Access Compliance Report

Public Rights-of-Way

(Curb Ramps)

Intersection ID: 10719	Main Street: CEMETARY_ST	Cross Street: N_SUMMIT_AV	Location: E
ADA ID: 291EDE3601F7	Ramp Type: PerpDiag	Initial Pass/Fail: Fail	Overall Compliance: No
			Severity Score: 33.75

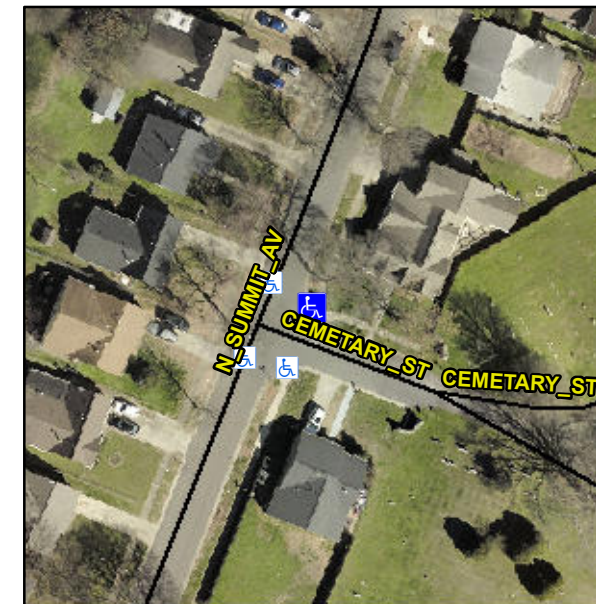
Not Found, R304.5.1, R304.5.3

Remove & Replace Curb Ramp With Two New Directional Ramps or Equivalent.
